CITY OF ALBUQUERQUE

RE: **FedEx Fuel Station**
Daytona Rd NW
Grading Plan Stamp Date: 7/16/18
Hydrology File: K09D026C

**RE: FEDEX FUEL STATION
DAYTONA RD NW
GRADING PLAN STAMP DATE: 5/29/18
HYDROLOGY FILE: K09D026C**

FEDEX GROUND
ALBUQUERQUE, NM
OVERALL GRADING
AND DRAINAGE PLAN

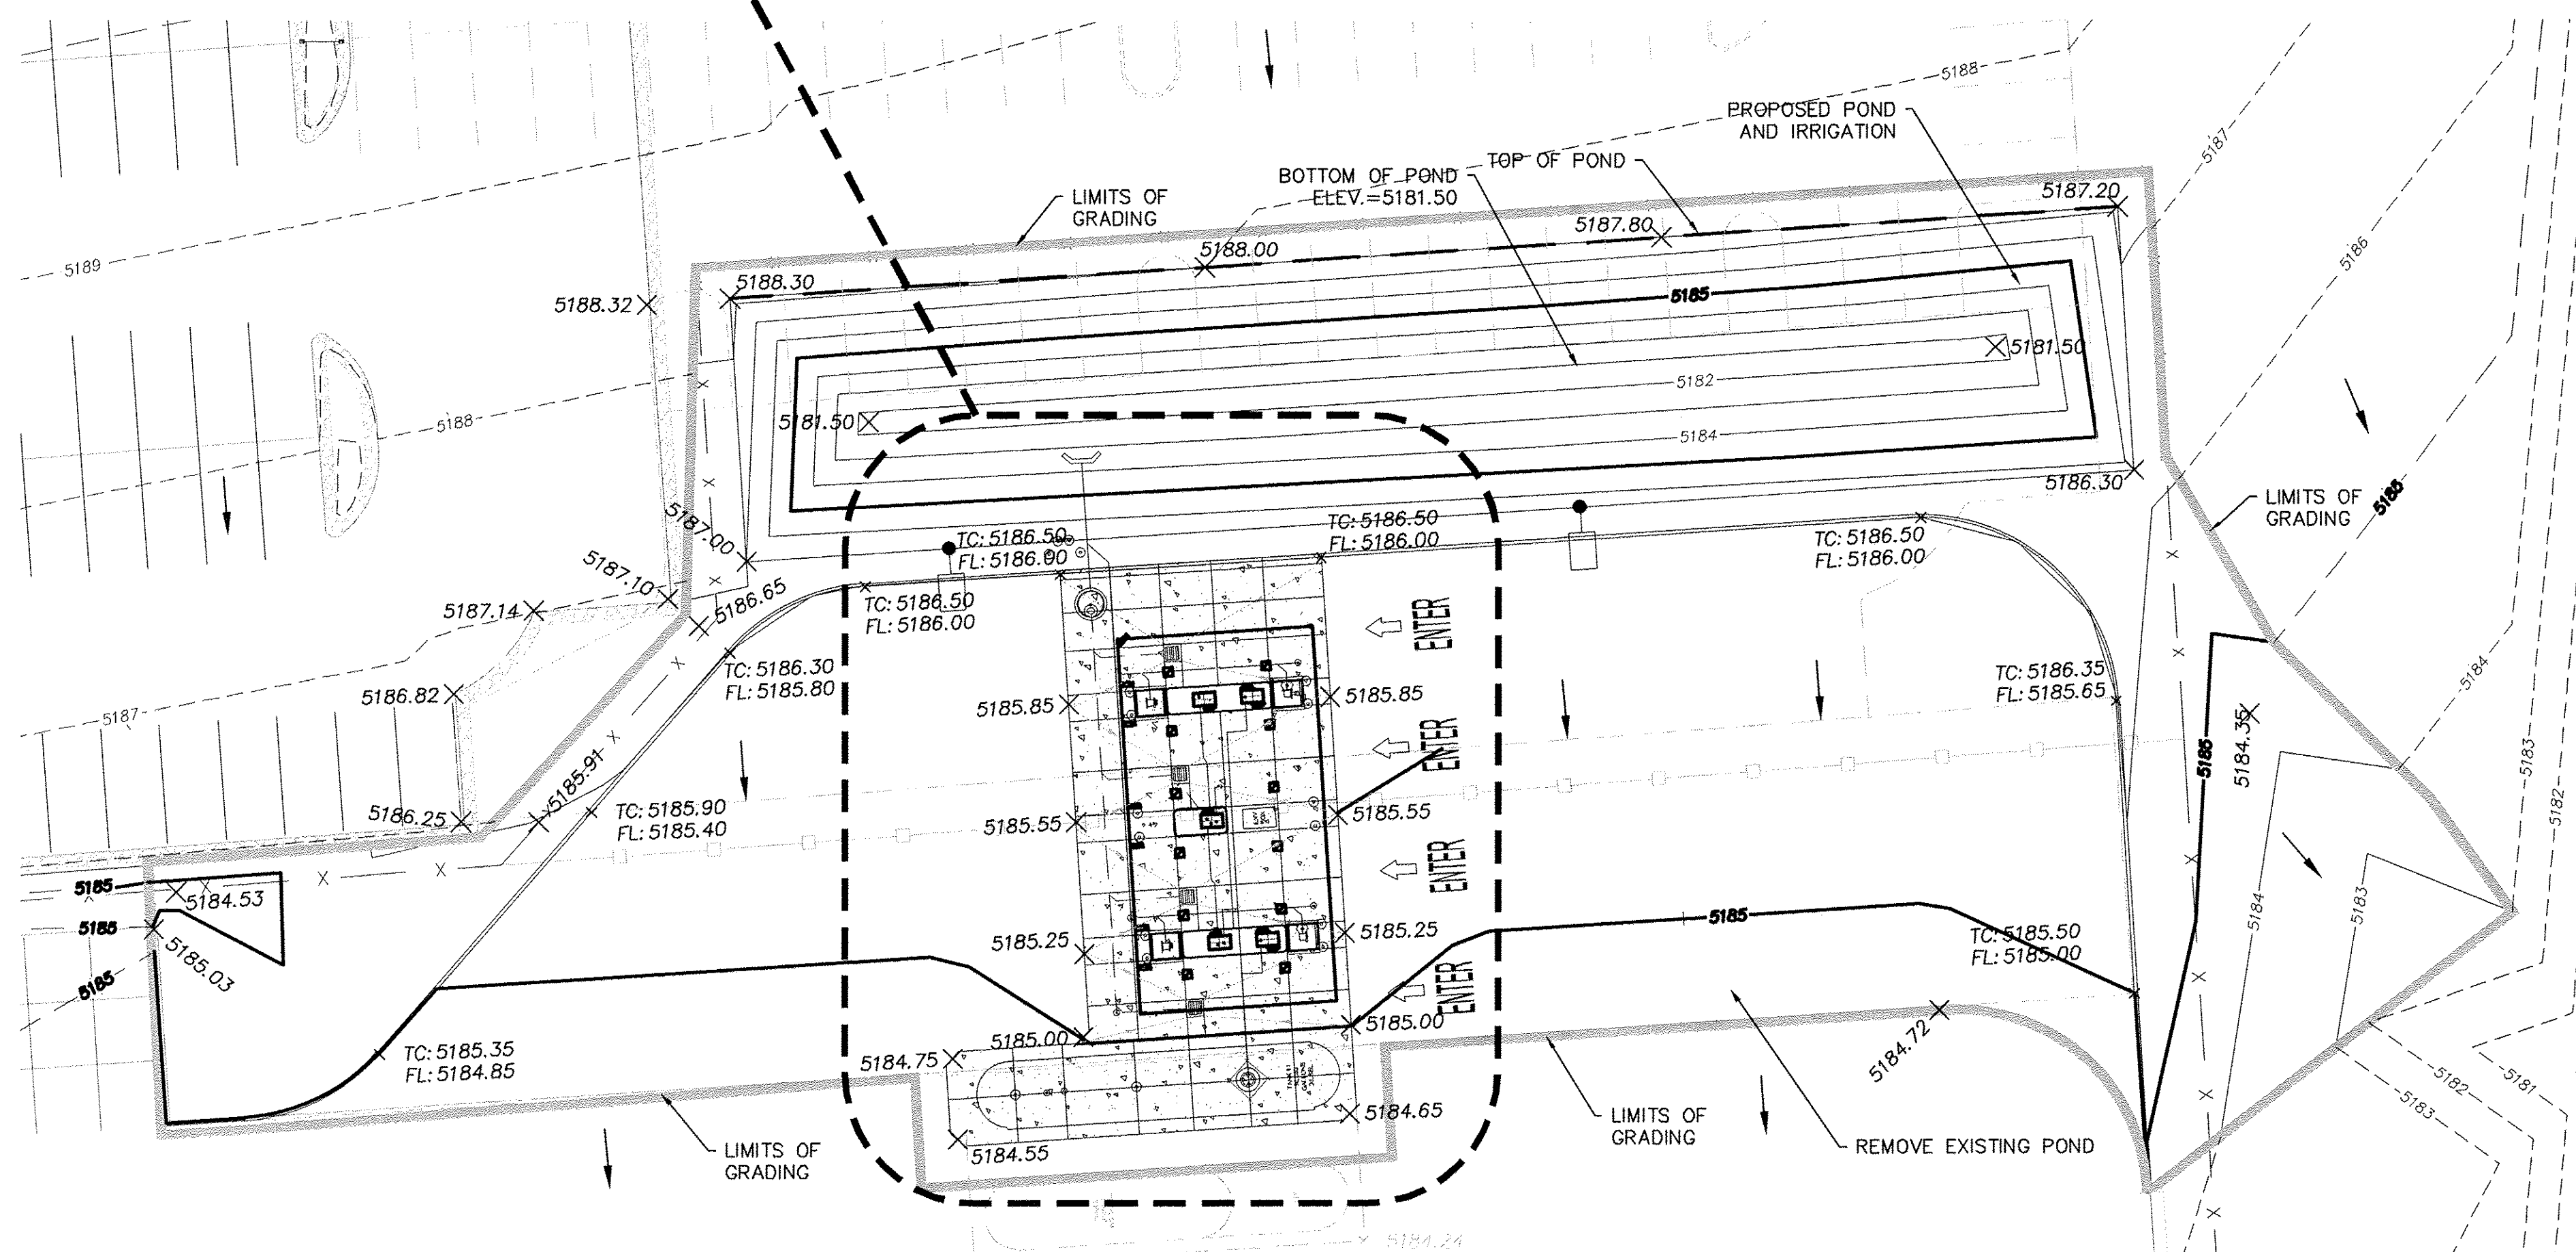
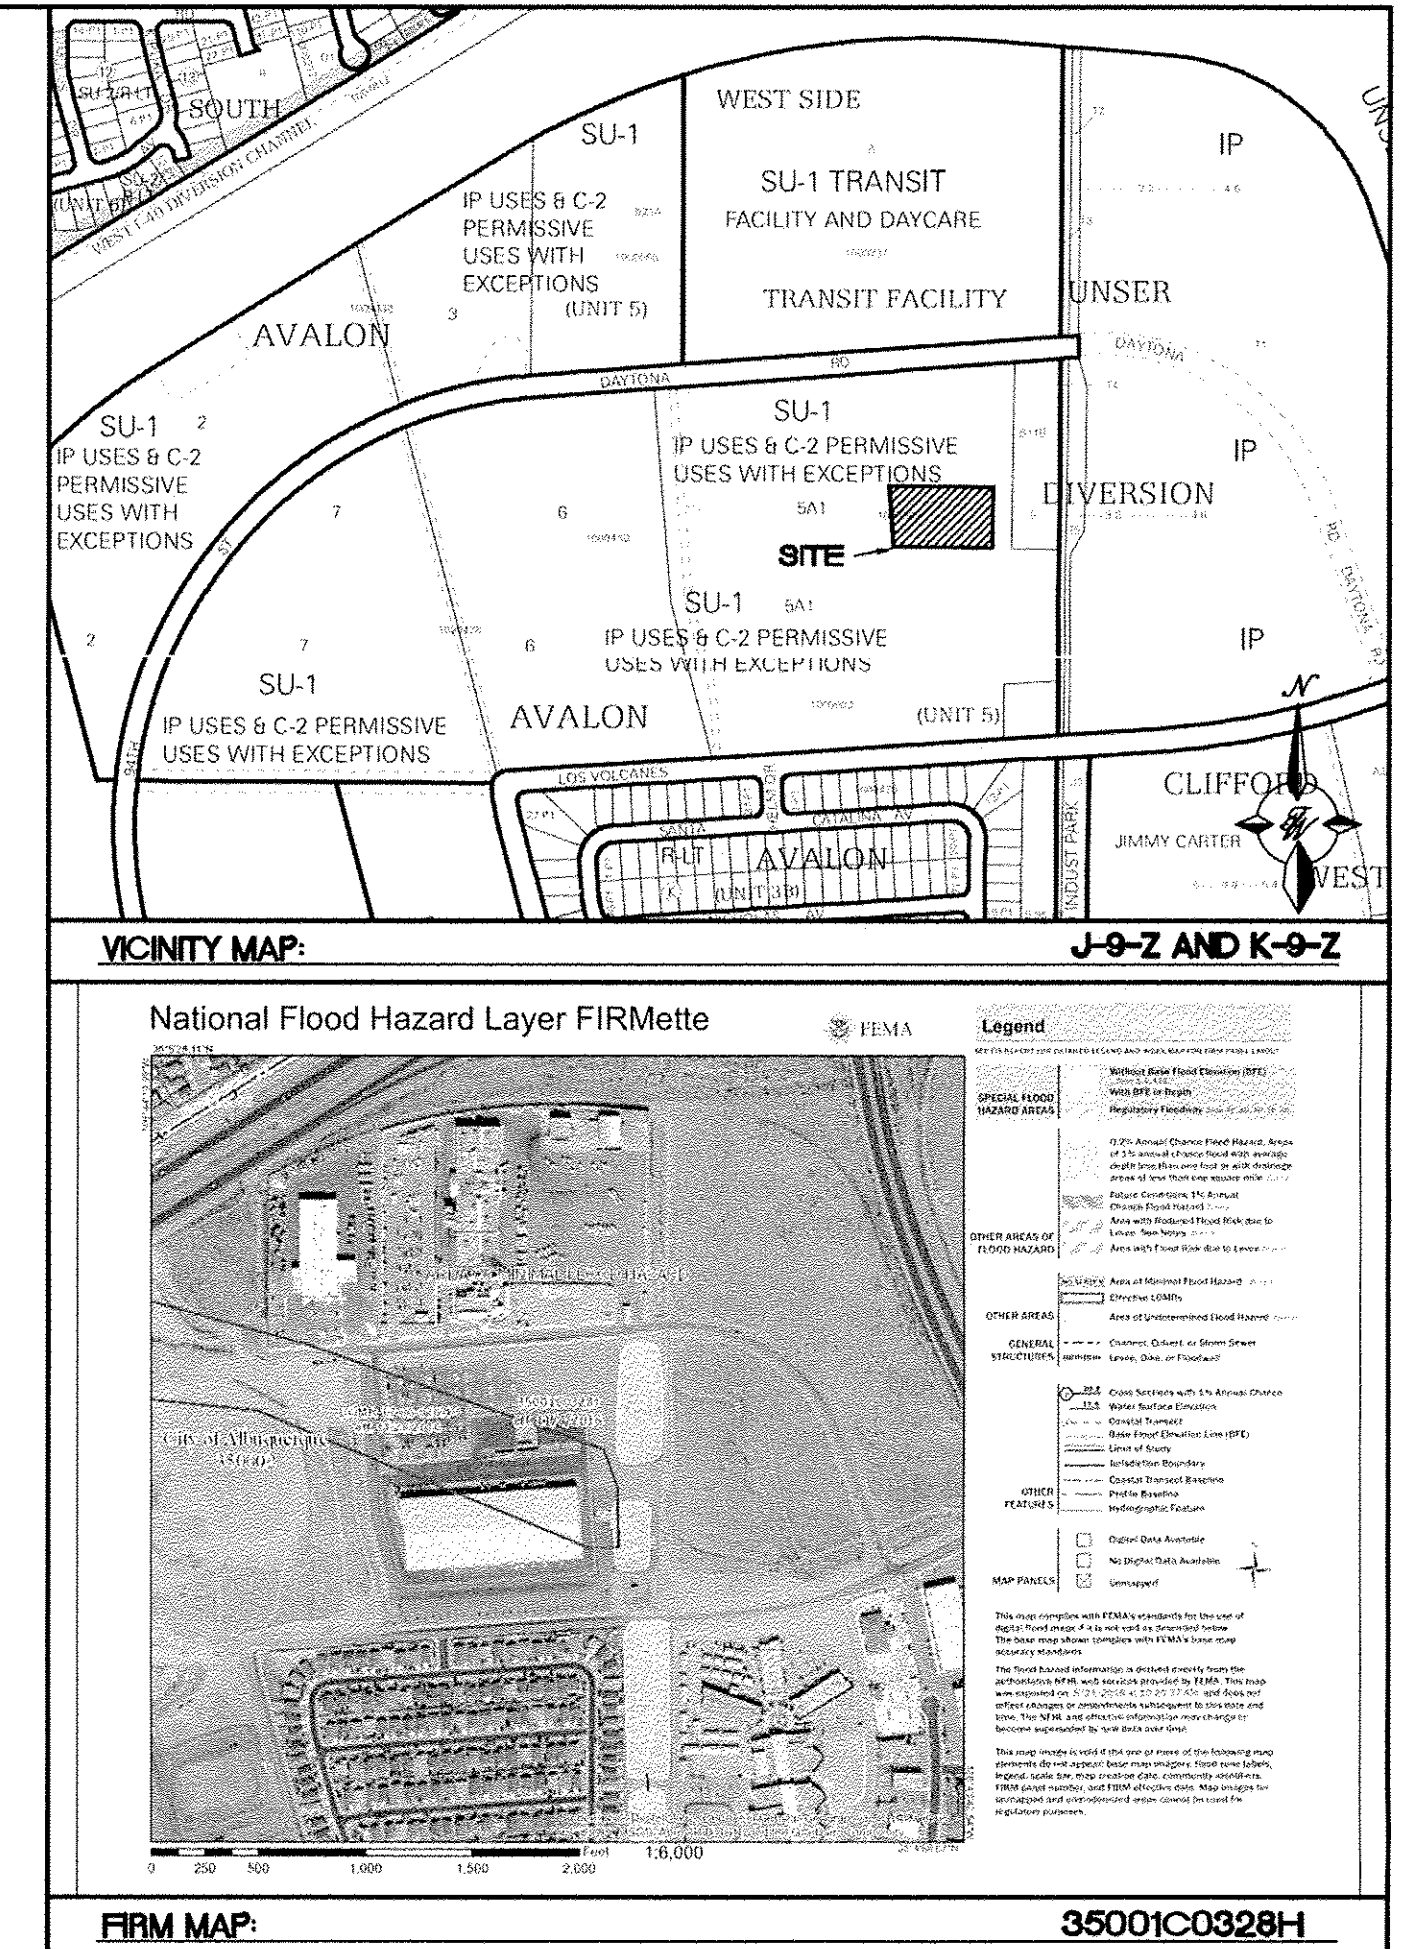
1. Include discussion of how the first flush is being retained on-site. Provide supporting calculations, drainage basin exhibits, etc. demonstrating that the area of new impervious (and redeveloped impervious, if any) will be routed to an adequately sized first flush facility.

Response: A paragraph discussing the first flush ponding was added to the grading plan. As noted in the original drainage report for the entire FedEx site, the detention pond was created with a first flush volume for all impervious areas, along with detention of developed flows. The volume of the desilting pond that will be moved to the north of the proposed fueling addition is not included in these permanent first flush and detention volumes.
